Notice of Intent

Type of Action: APD Change

James Ranch Unit DI 8 East 114H (30-015-55828)

James Ranch Unit DI 8 East 804H (30-015-55829)

Previous Design: 4-String Design – Engineered Weak Point**[Figure F] 4 String – 2nd Intermediate casing engineered weak point**

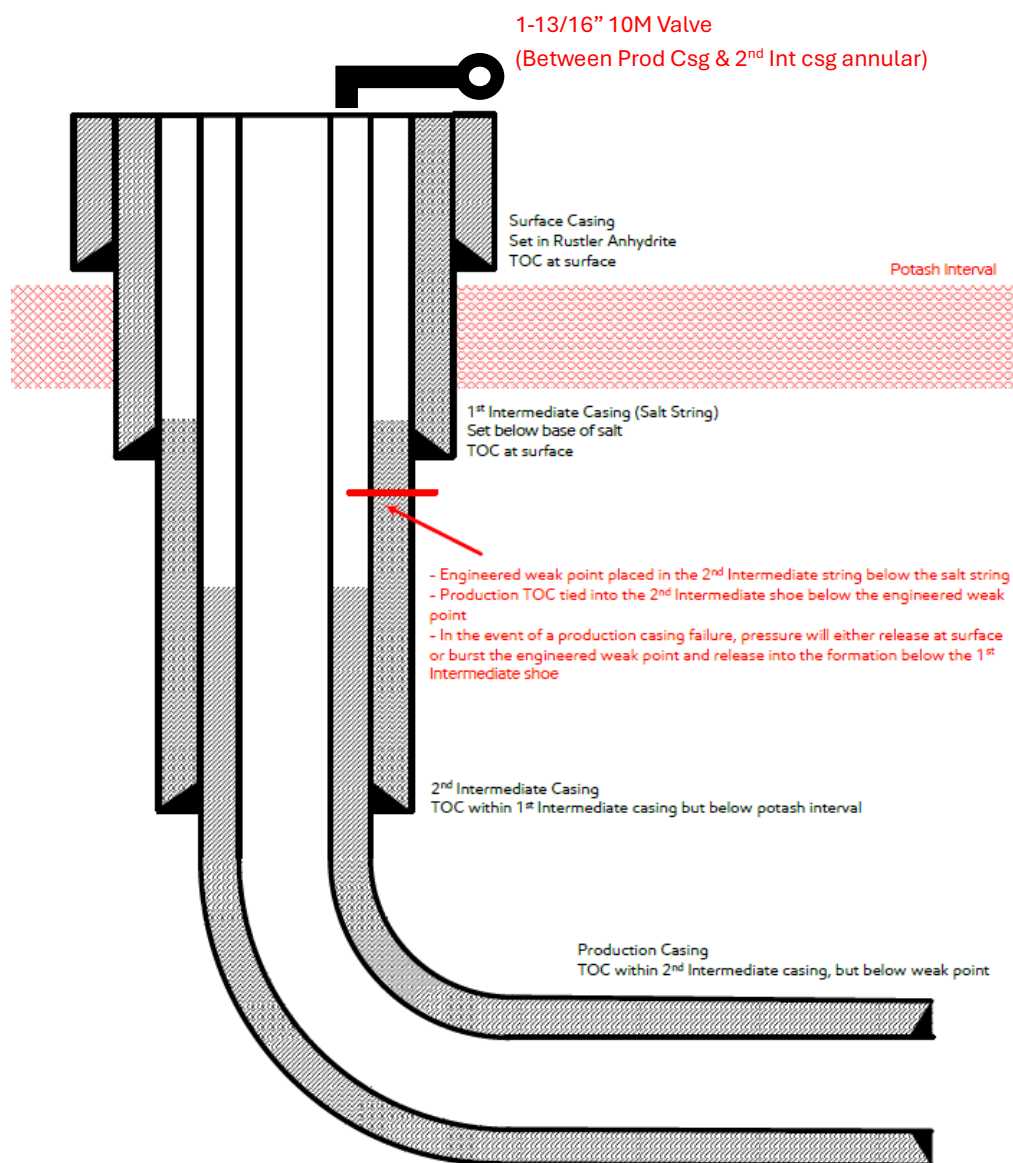
1. Casing design to be changed from the "4-String Design – Engineered Weak Point" (FIGURE F) to the "4-String Design – Open 1st INT x 2nd INT Annulus" (FIGURE D). An open annulus will be utilized and monitored during completions operations.

Post completion, bradenhead squeeze will be performed to tie back the 1st intermediate x 2nd intermediate annulus. TOC will be placed into the 1st intermediate shoe but still below the base of Potash interval.

- 1) Alignment with KPLA requirements per schematic per schematic below, with engineering weak point casing design and utilizing new casing that meets API standards.
- 2) Contingency plans in place to divert fluids away from salt interval in event of production casing failure.
- 3) Intermediate 2 casing will consist of a primary cement job with TOC at the top of the Brushy Canyon formation within the Delaware Mountain Group.
 - a. Bradenhead squeeze to be completed after primary cement job to tie back TOC to intermediate 1 "Salt string" at least 500' but with top below Marker Bed 126 "Potash Interval".
- 4) Production cement to be tied back no less than 500' inside previous casing shoe (intermediate 2 casing) and below the engineered weak point.

New Proposed Design: 4 – String Design – Open 1st Int X 2nd Int Annulus (ICP 2 below relief zone)**[Figure D] 4 String – Uncemented annulus between 1st and 2nd intermediate casing strings**

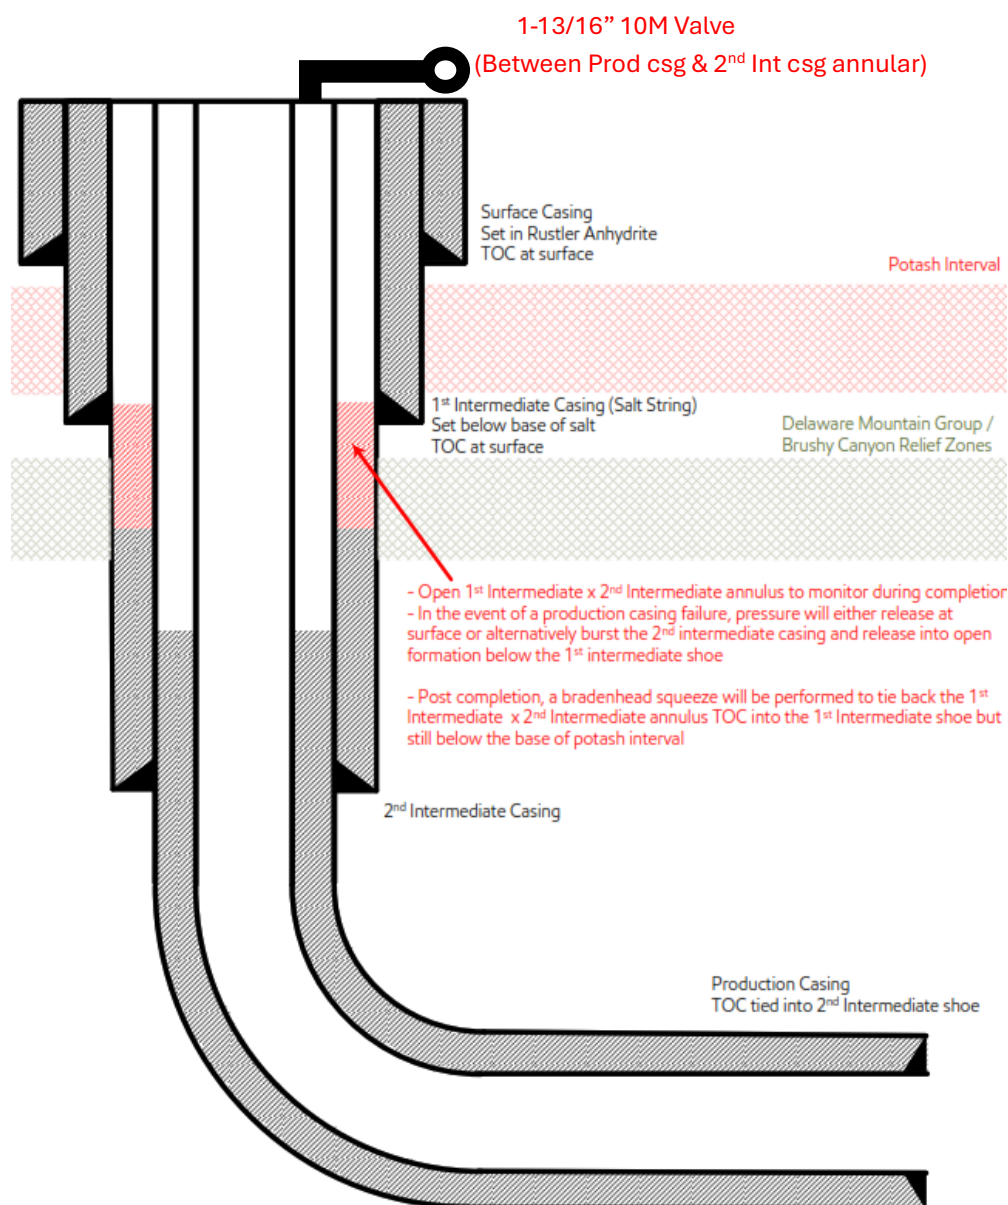
Please refer to the R-111-Q well bore diagrams attached below reflecting the changes requested.

- 1) Alignment with KPLA requirements per schematic above, leaving open annulus open for pressure monitoring during frac and utilizing new casing that meets API standards.
- 2) Contingency plans in place to divert fluids away from salt interval in event of production casing failure.
- 3) Intermediate 2 bradenhead squeeze to be completed within 180 days to tieback TOC to salt string at least 500ft but with top below Marker Bed 126.
- 4) Production cement to be tied back no less than 500ft inside previous casing shoe.
